CALIFORNIA COASTAL COMMISSION

STAFF REPORT: REGULAR CALENDAR

APPLICATION NO.: 4-01-214

PROJECT LOCATION: 25257 Mulholland Highway, Calabasas, Los Angeles County

EXHIBIT NO. 13
APPLICATION NO. C-01-214
Grading Plan

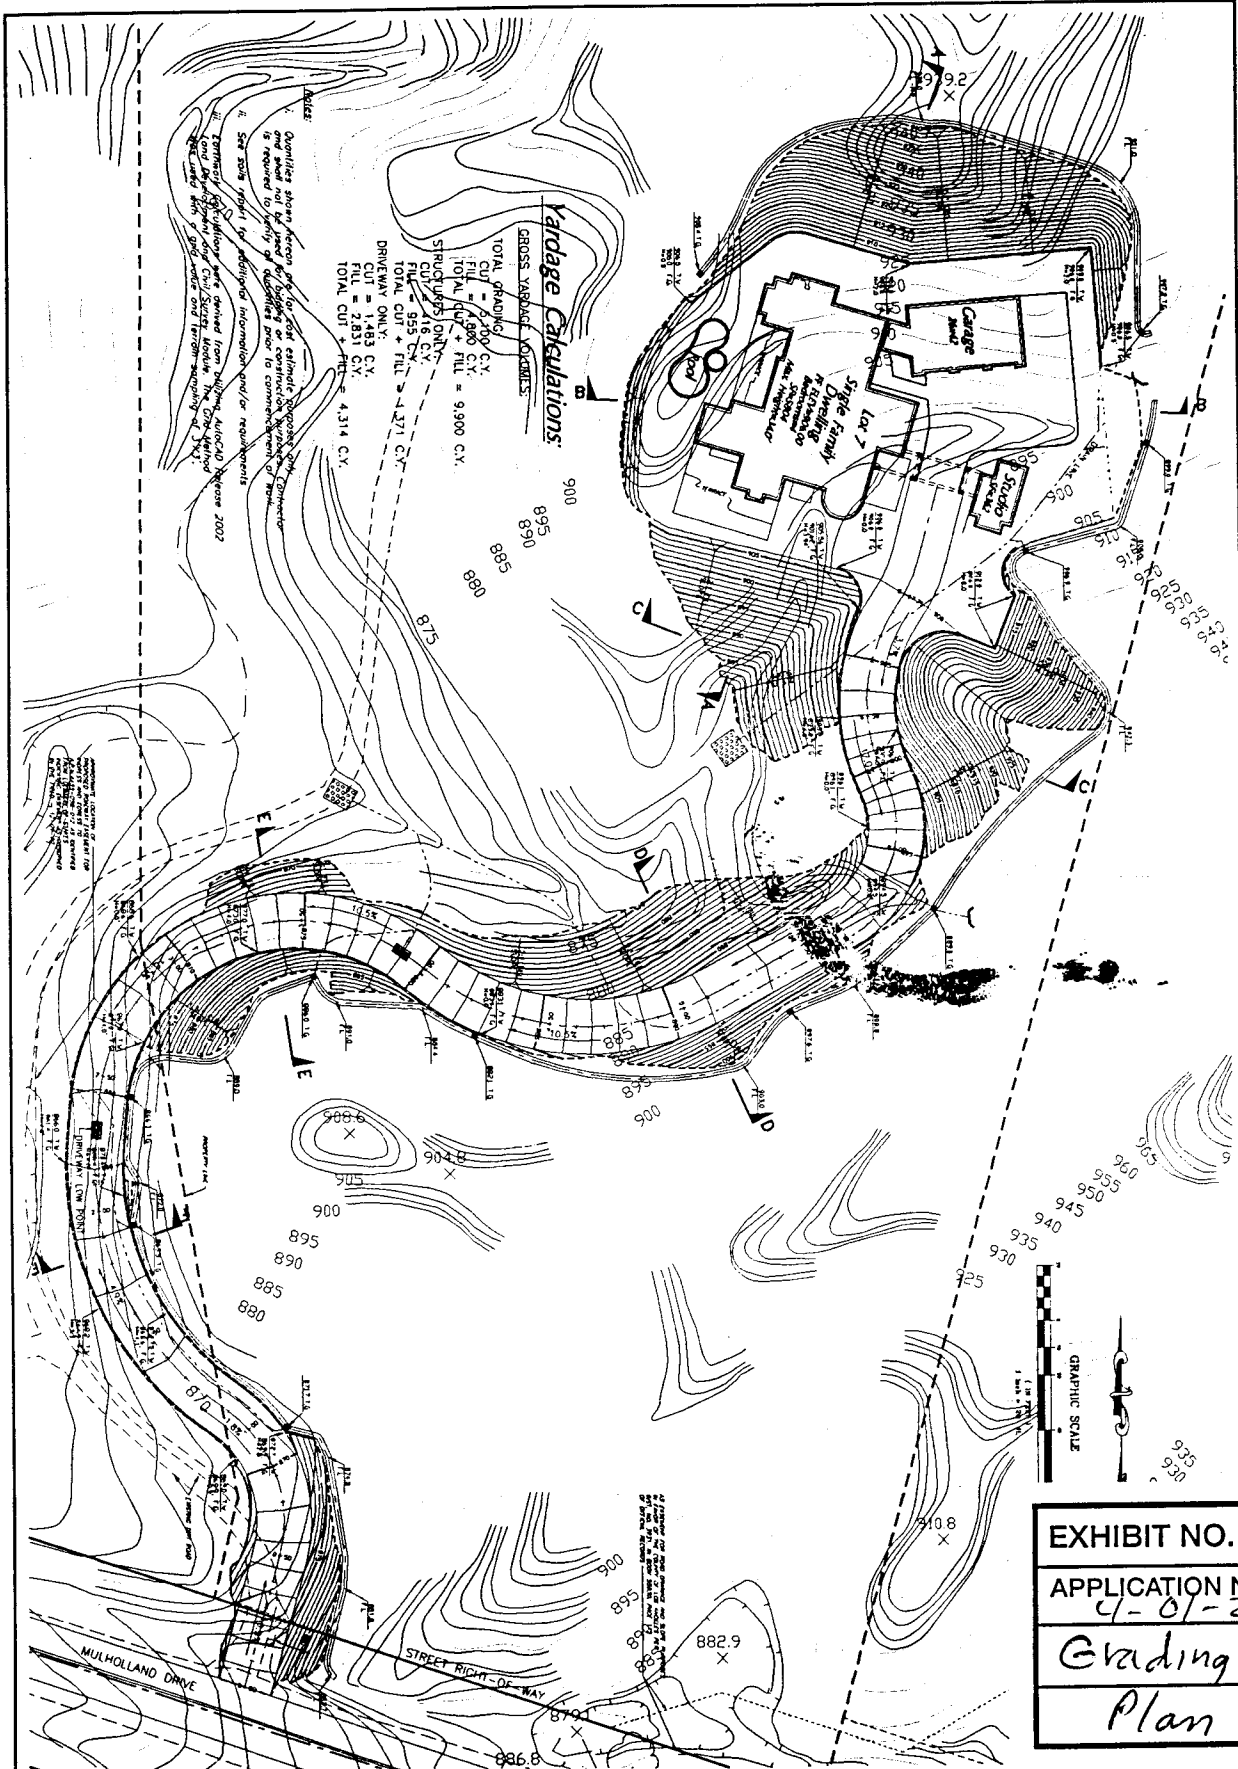
The applicant proposes to construct a driveway from Mulholland Highway beginning at the southwest portion of the property traversing south and climbing along west slope of a small knob hill across the a portion of the adjoining property located to the west. (See Photo Exhibit 31). The driveway then turns east returning to the applicant's property and continuing to the eastern portion of the property located inland of the knob hill. At a location of about 370 feet inland from Mulholland Highway, the driveway is proposed to climb a filled slope located over and crossing a drainage gully to a proposed building pad with over 50% of the pad filled with cut material to a maximum depth of about 19 feet at the south-central edge of the building pad. The proposed residence is a two story 35 foot high from finished grade structure with attached three car garage and studio. The maximum cut required for this proposed 16,300 sq. ft. flat building pad is 21 feet near the northeast corner of the pad. Exhibit 28 identifies the cut/fill line on the proposed building pad at the 906 foot elevation. This grading plan identifies that creating the proposed approximate 680 foot long driveway requires 1,483 cubic yards of cut and 2,831 cubic yards of fill, totaling 4,314 cubic yards of grading. The grading plan identifies that 416 cubic yards of cut and 955 cubic yards of fill totaling 1,371 cubic yards of grading is needed for the "structures only". A careful review of this grading plan indicates that 3,617 cubic yards of cut and 1,969 cubic yards of fill are needed to

create the 16,300 sq. ft. building pad. Including the cut slope along the north and east sides of the building pad but not the south side where the driveway accesses the pad and hammerhead turnaround, the entire building pad is estimated by Staff to be about 22,000 sq. ft. in size.

Based on the above, the proposed residence, garage, studio, building pad area, and 680 foot long driveway, with a total of 9,900 cubic yards of grading will all create a highly visible development from Mulholland Highway and the proposed public trails noted above. Because the proposed development will be highly visible from public locations, and will involve a significant amount of grading and landform alteration, the development is found inconsistent with Coastal Act Section 30251 which requires that grading and landform alteration for new development be minimized, visually compatible with the surrounding area, and that the visual qualities of coastal areas shall be considered and protected as a resource of public importance.

EXHIBIT NO. 28
 APPLICATION NO.
 07-01-214
 4th Site/Grading
 Plan; Current Proposed Project

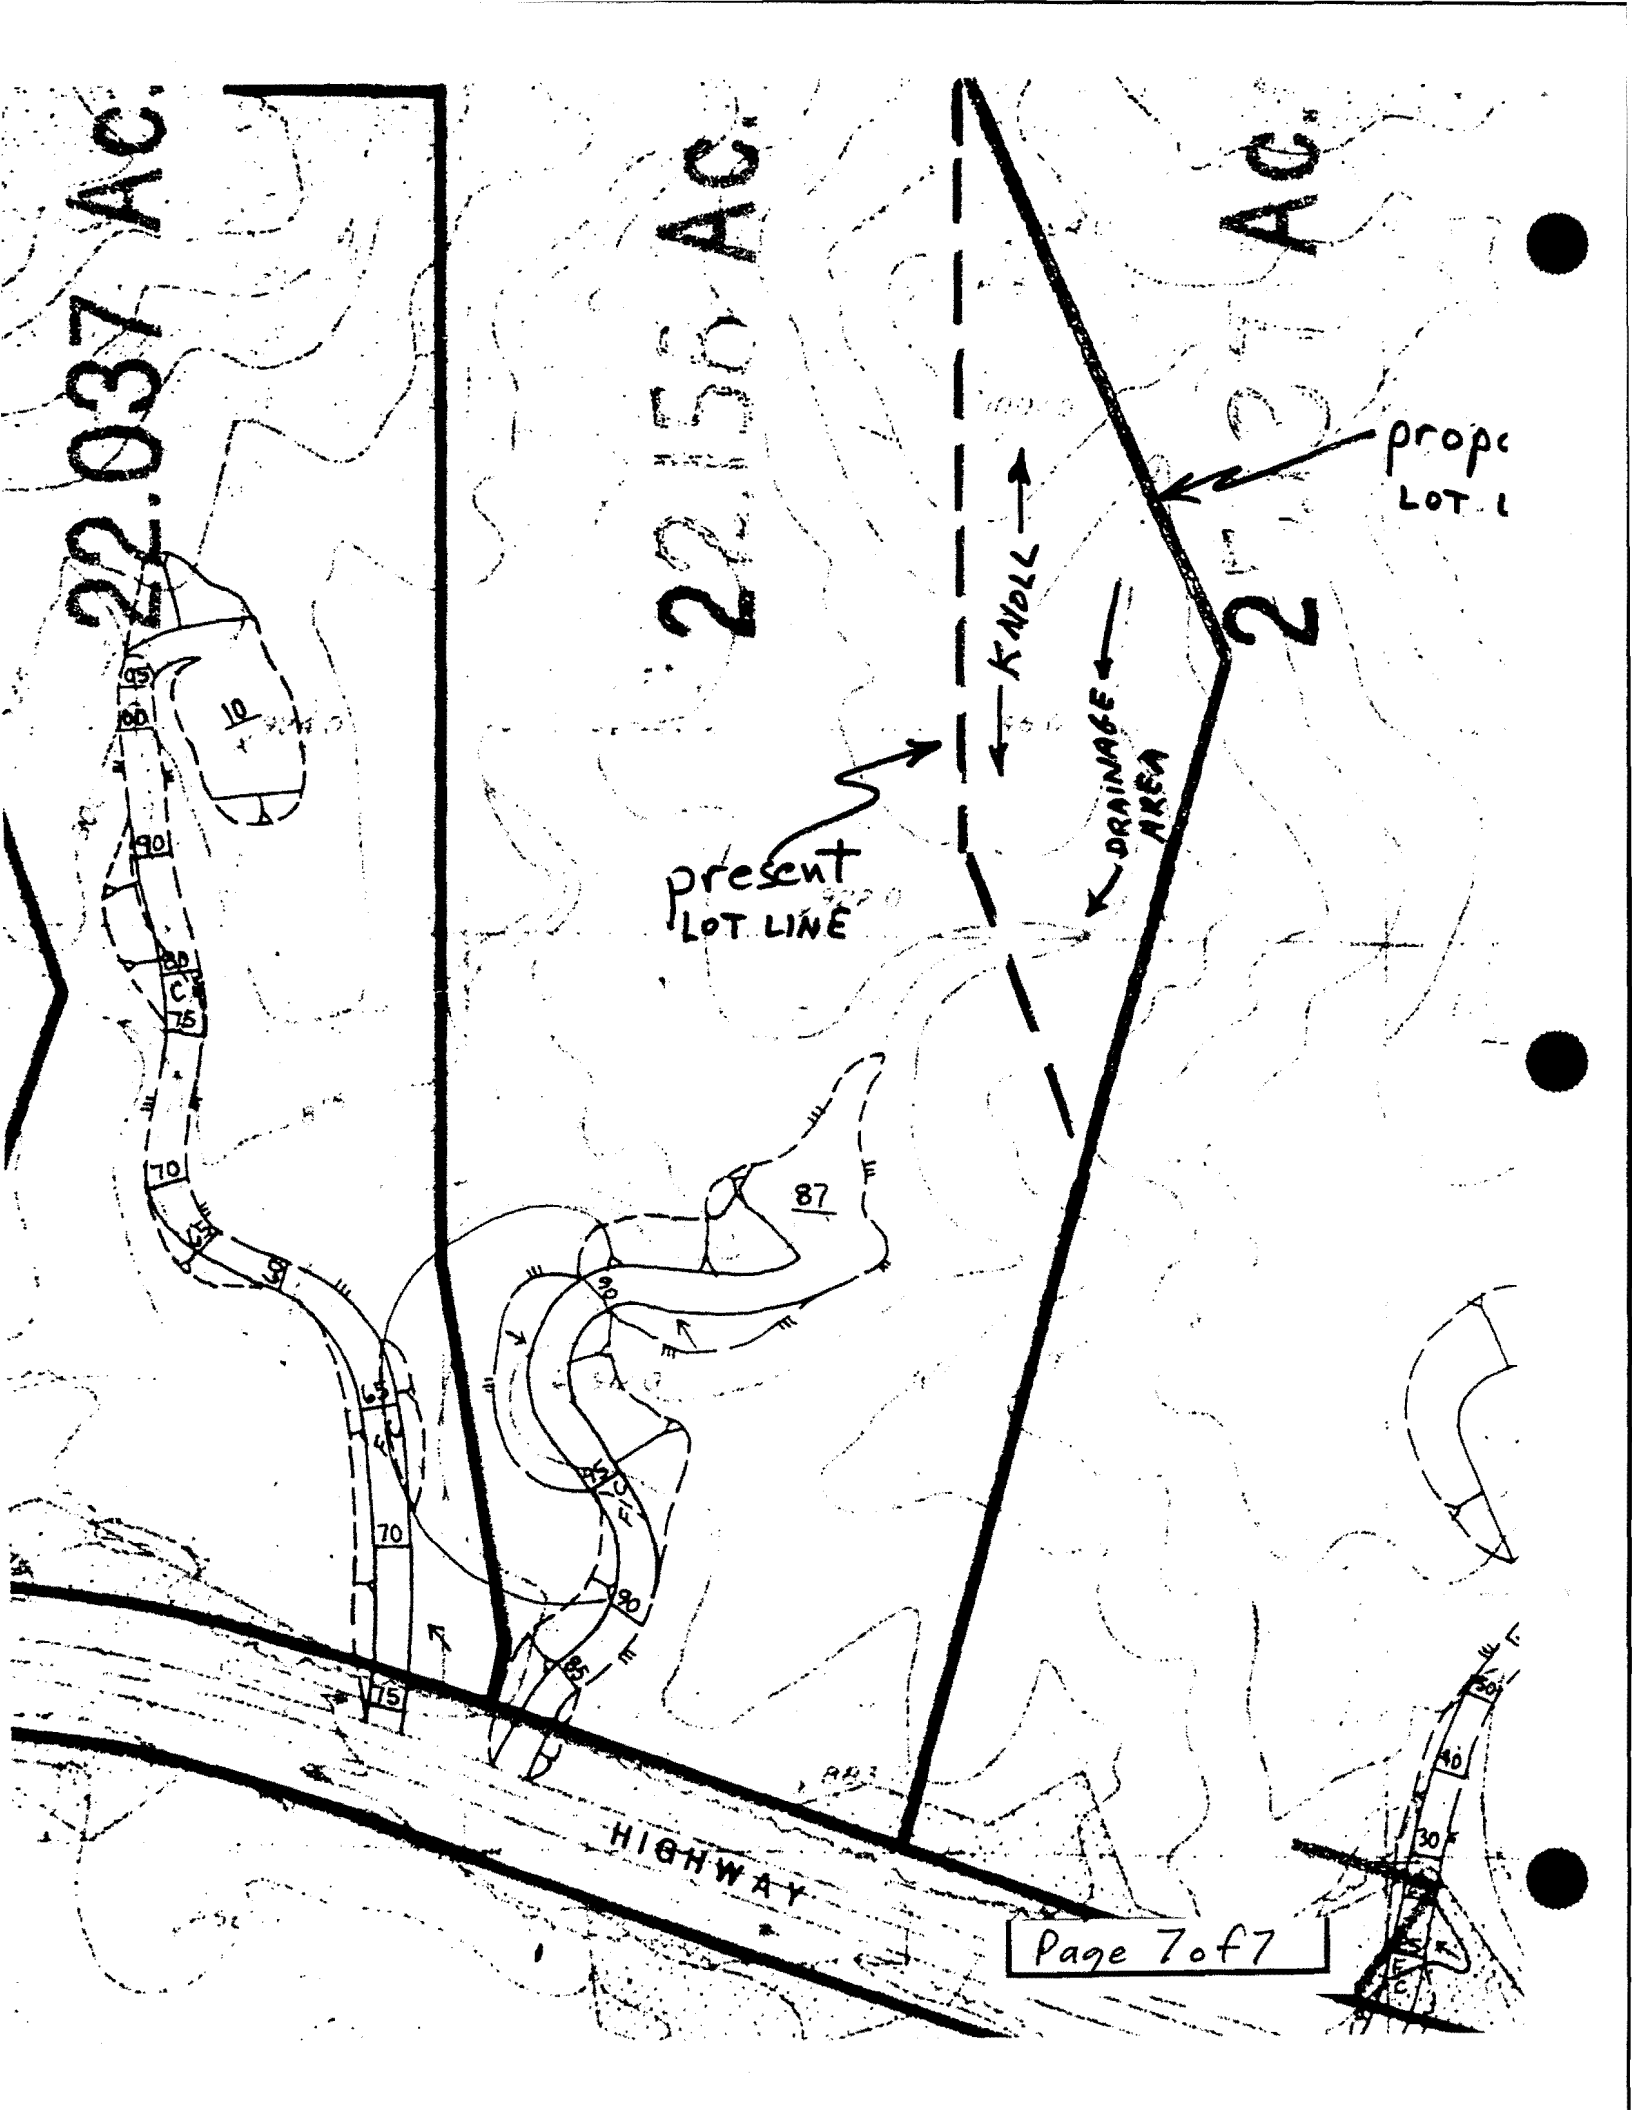
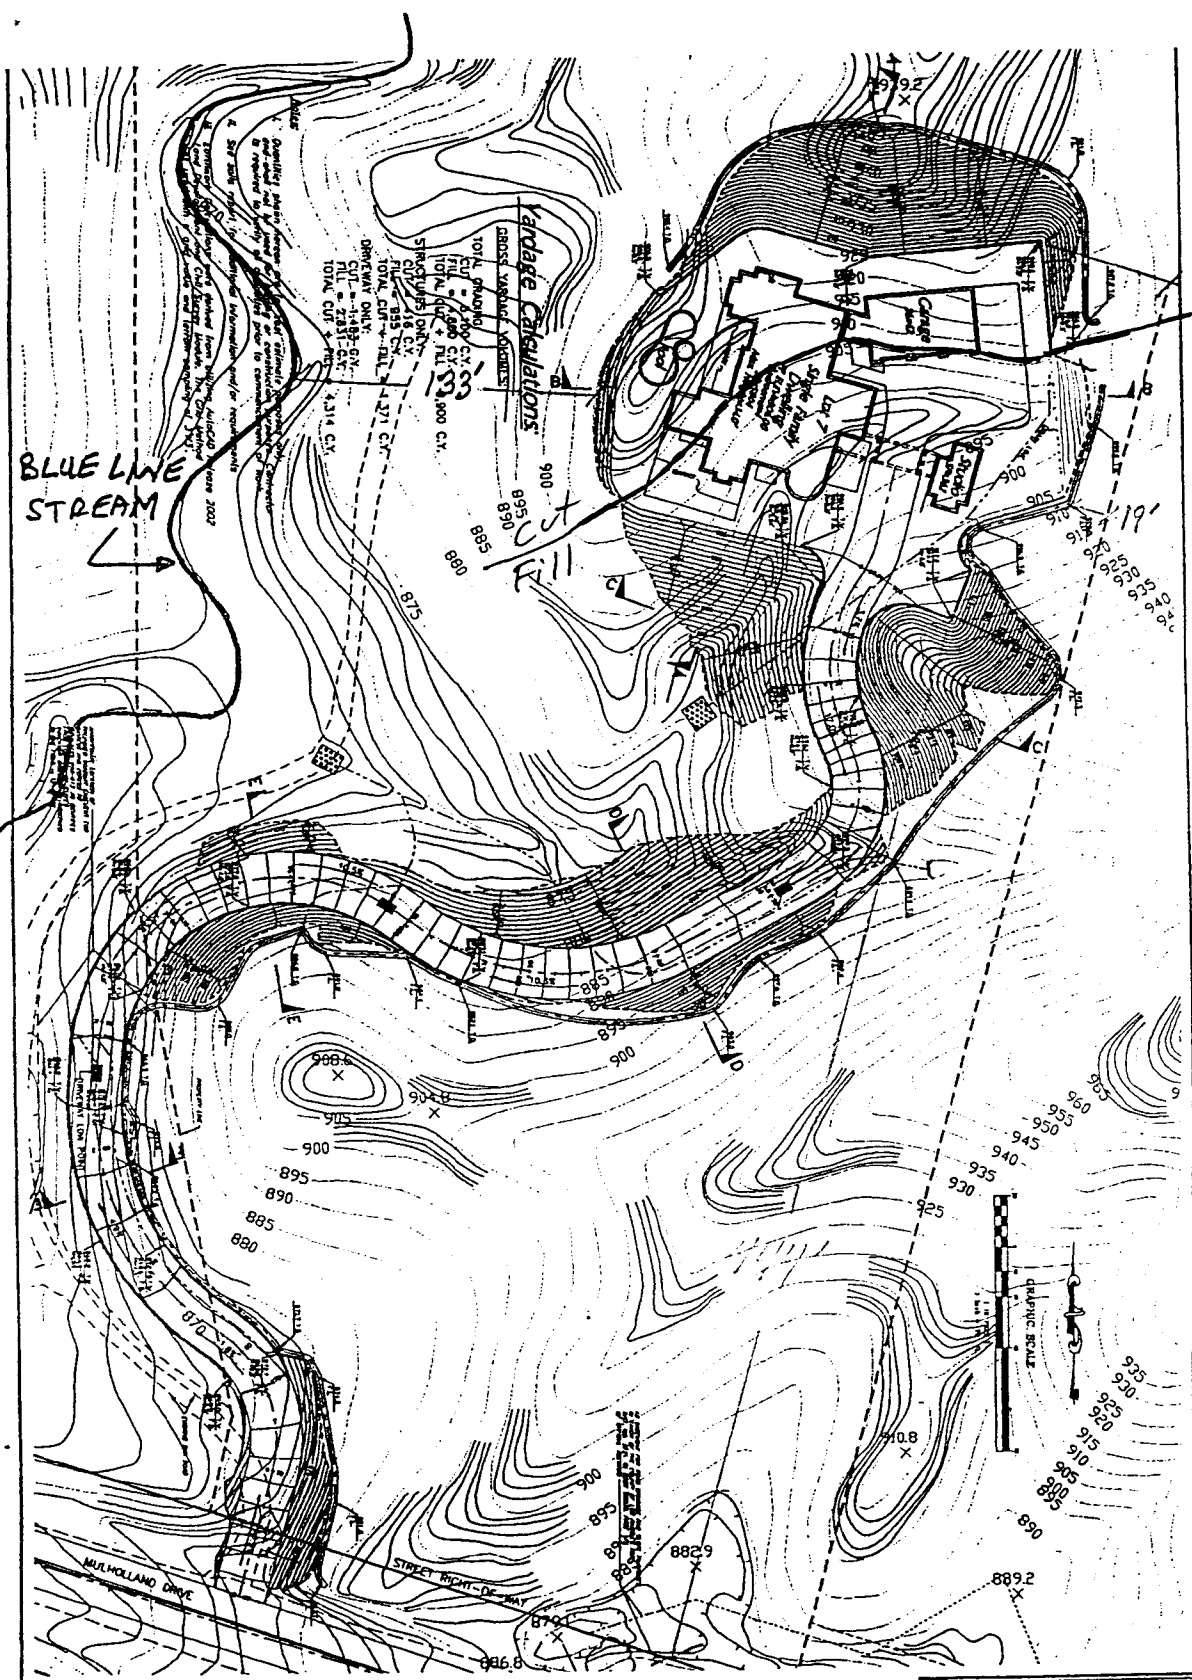
On July 29, 2002, the applicant submitted additional application materials for the revised project proposing the residence at the original building site with revised grading total of 12,000 cubic yards of material. This revised site/grading plan is attached as Exhibit 26. Staff reviewed this additional application material in a letter dated August 23, 2002 requesting one last information item requested since December 26, 2001. In this August 23, 2002 letter, Staff noted a continued concern regarding the large quantity of grading proposed for the building pad and driveway based on a review of recent permit actions by the Commission (Exhibit 27). Staff provided a copy of relevant pages of the staff report for Coastal Permit No. 4-93-203 (Kozma and Navaro) which resulted in the lot line adjustment of the subject parcel (Exhibit 27). In this August 23, 2002 letter, Staff also noted that the applicant's engineer estimated that this parcel could be developed with a maximum of 3,000 cubic yards of grading. Staff again suggested that the applicant redesign the proposed project to bring it into consistency with Coastal Act

Section 30251 that requires that landform alternation be minimized. It was suggested that the project be redesigned to reduce the size of the building pad, relocated the pad and driveway to substantially reduce the proposed grading.
